Addendum No. 3

Project Name: NECSD – New CTE Building

CSArch Project No. 108-2303

1 ENLARGED FLOOR PLAN - LOCKER ROOMS
A611 1/4" = 1'-0"

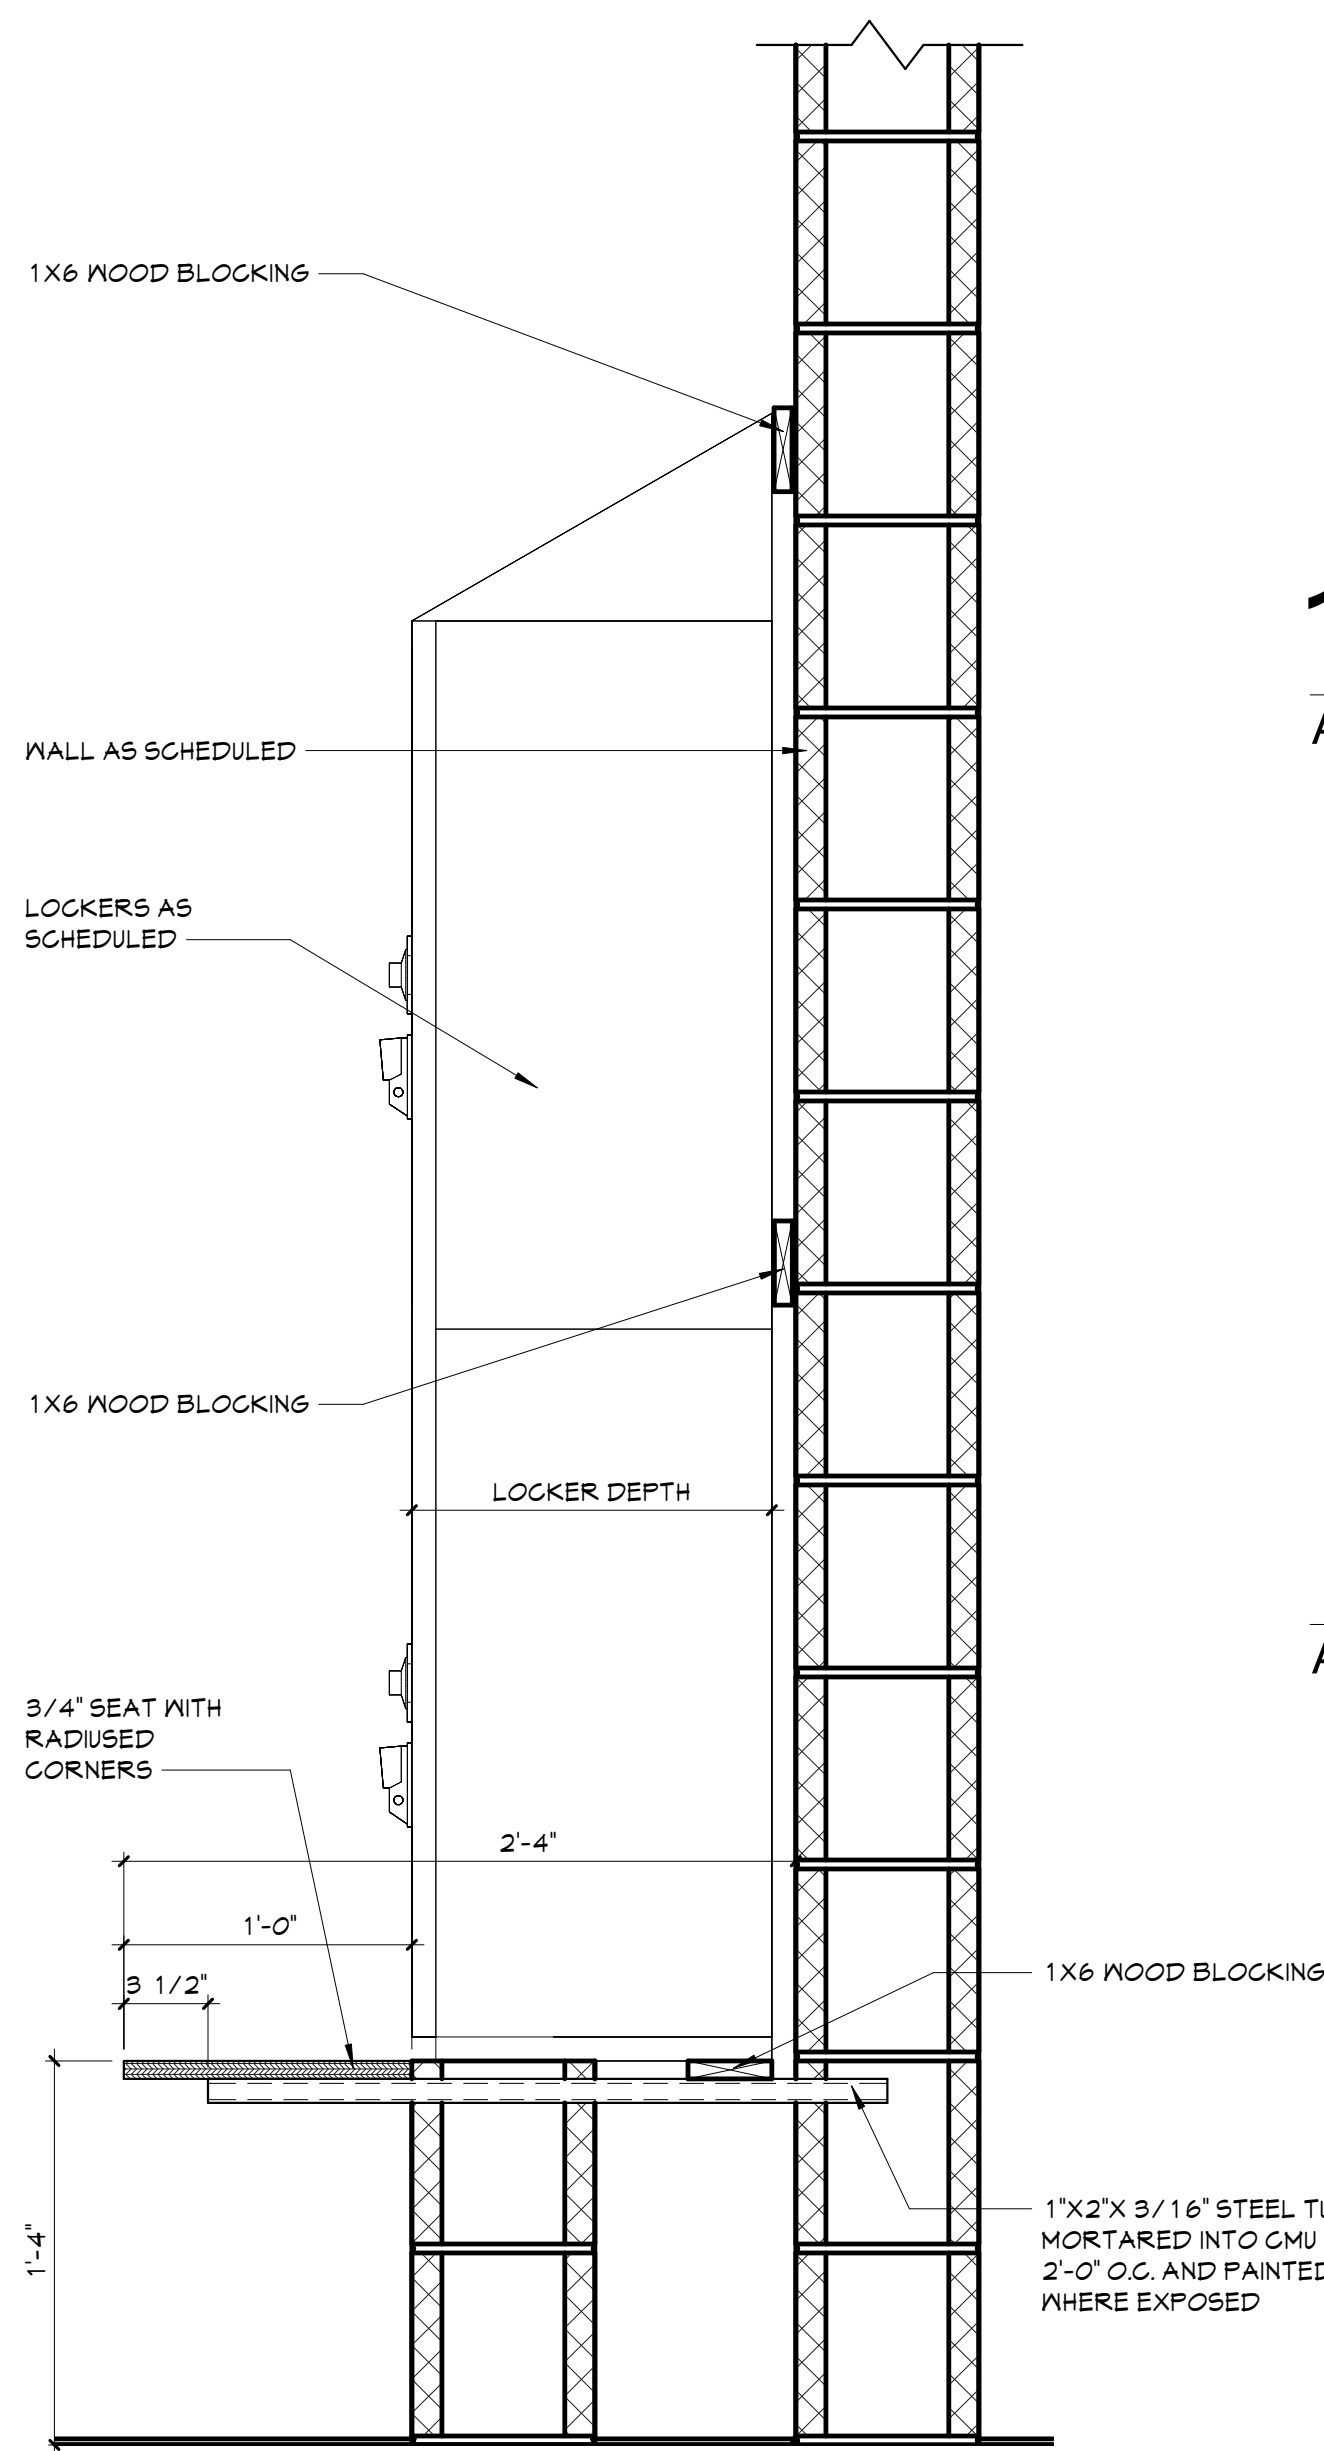
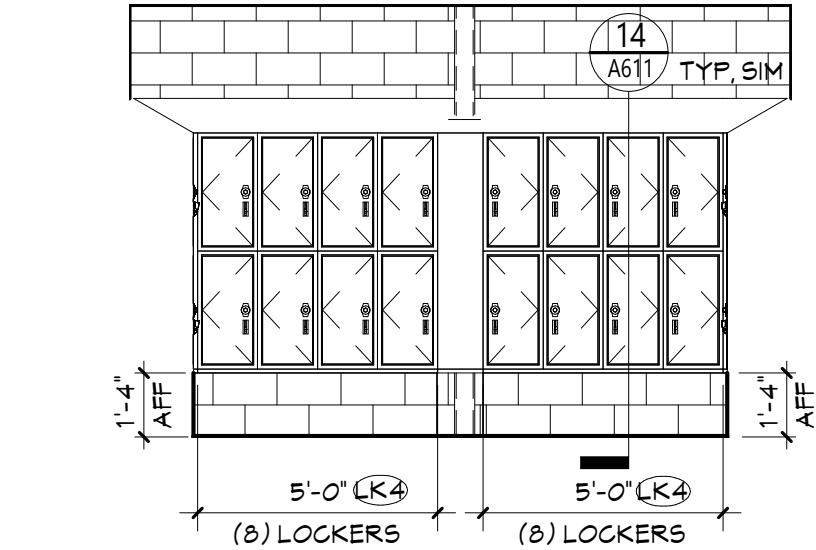
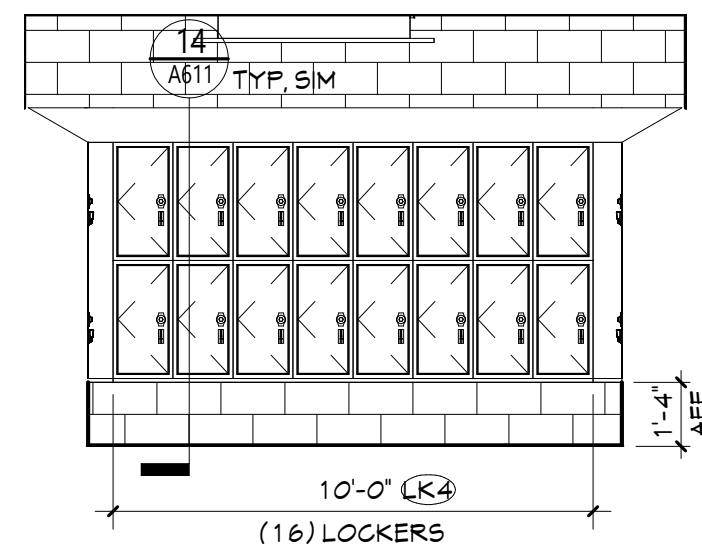
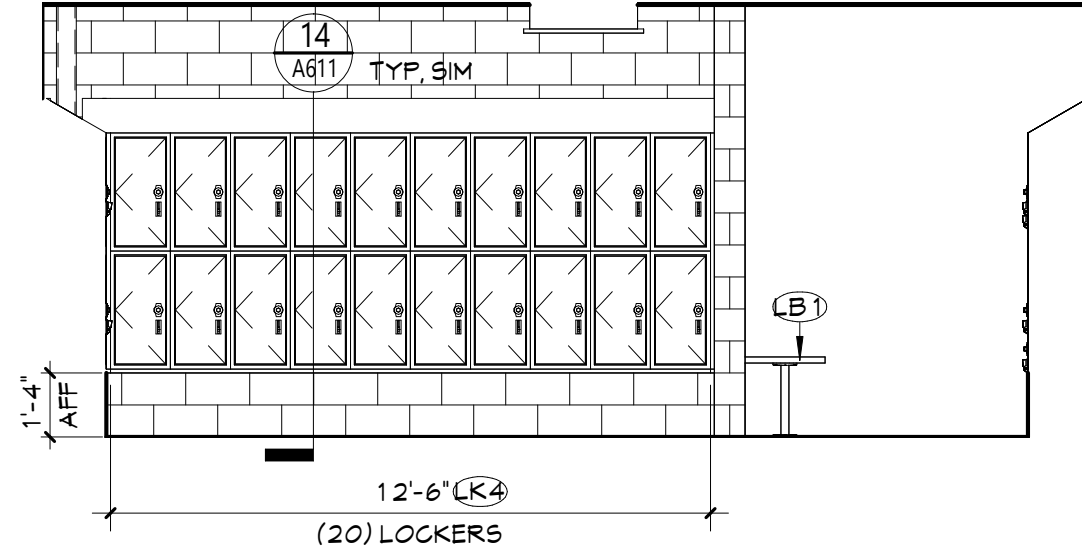
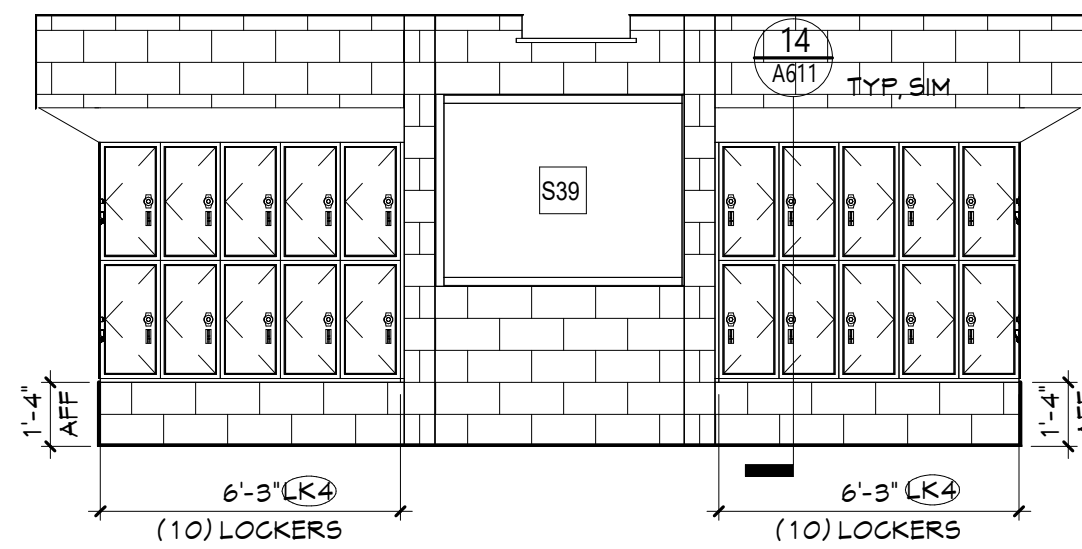
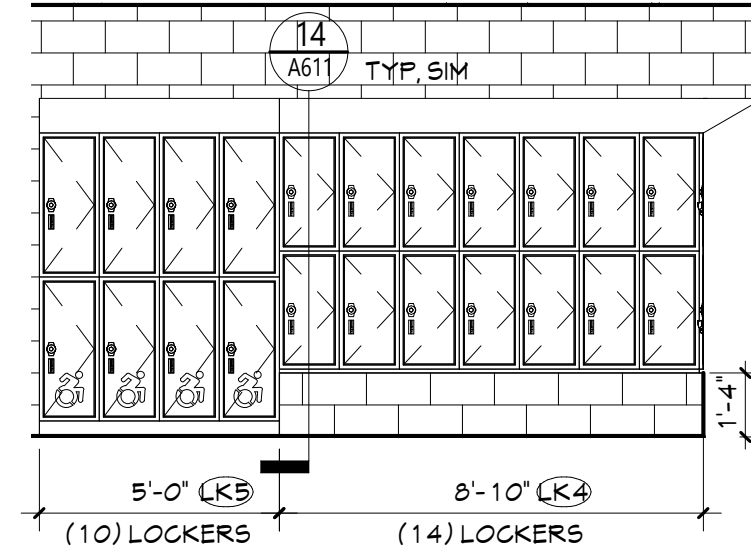
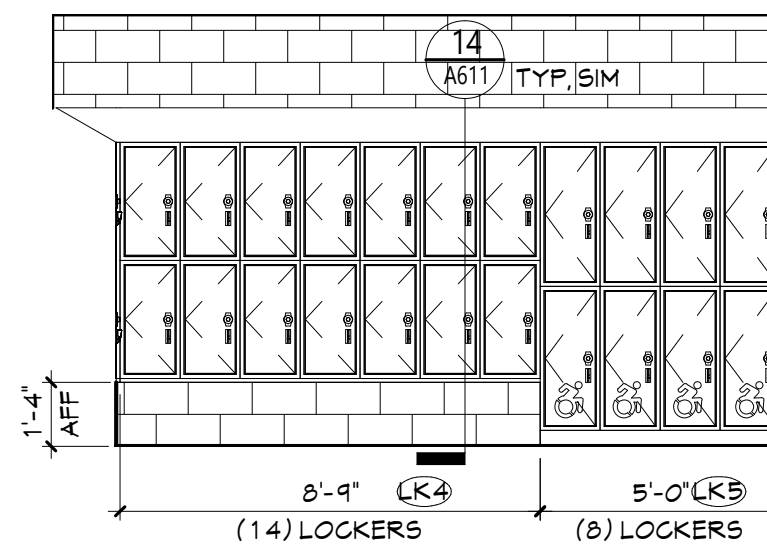
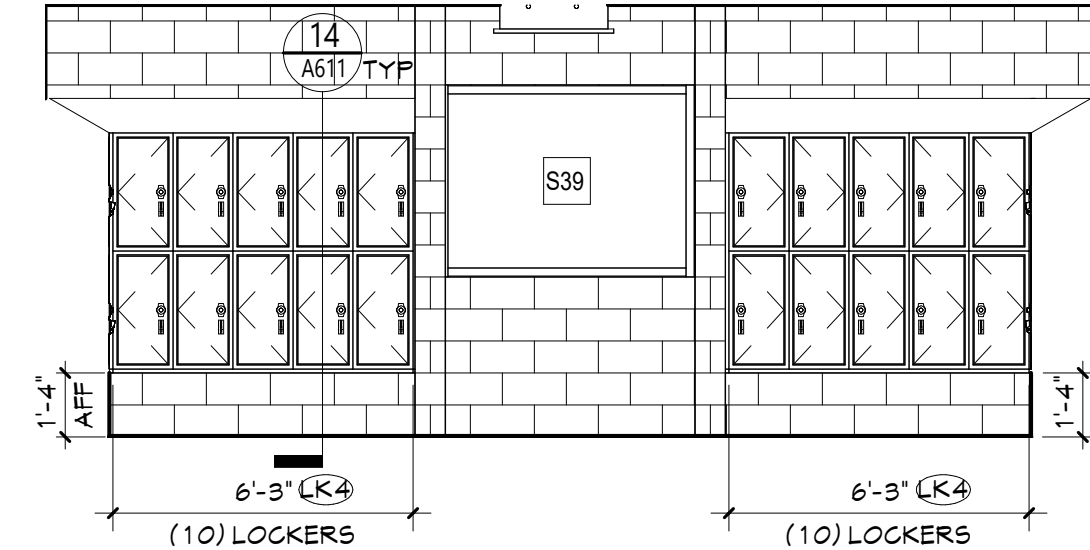
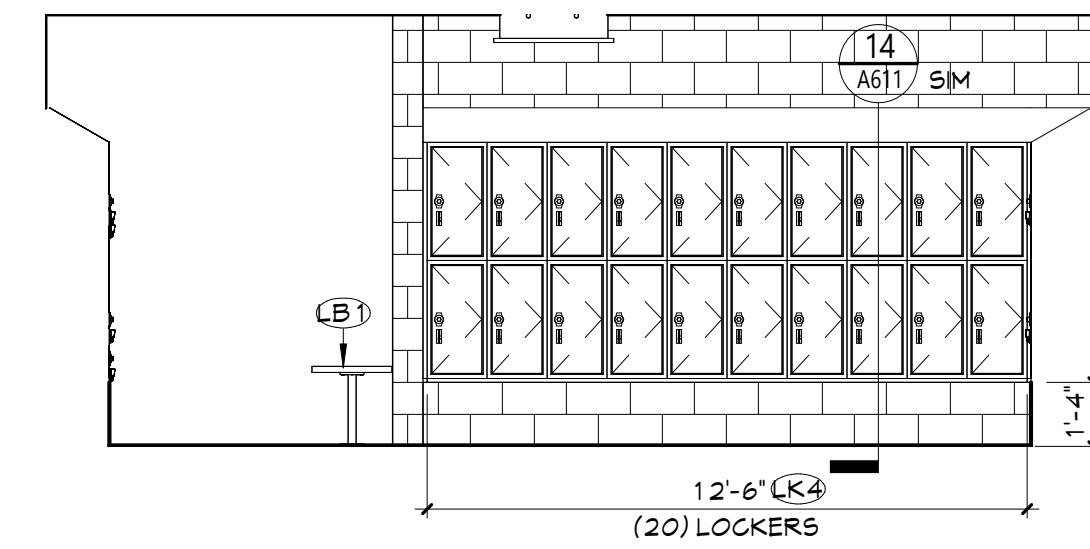
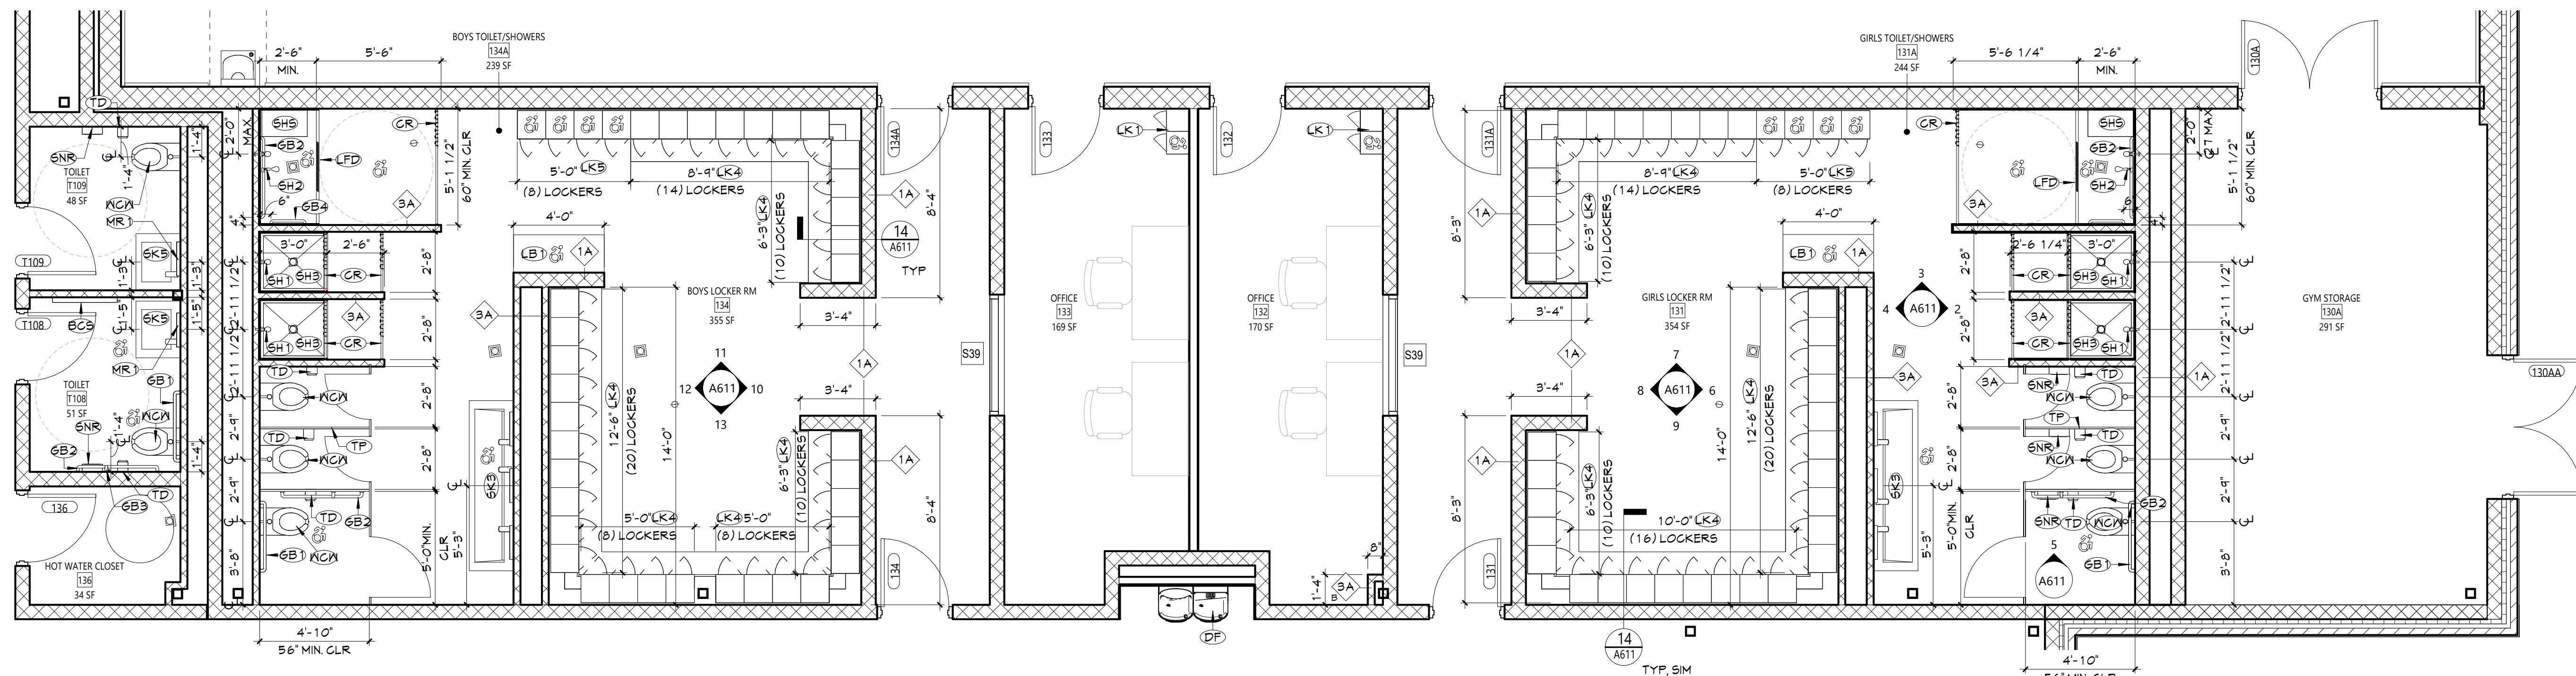
| 26 | A | Ceramic Tile | Finish Plan Dr. AF113 shows CWT wall tile at Locker Rooms. However elevations Dr. A611 shows no CWT. Please clarify. | 5/6/2024 | Worth Construction Co., Inc. | Revised as part of addendum #3 | Yes | A611 | | Add #3 |
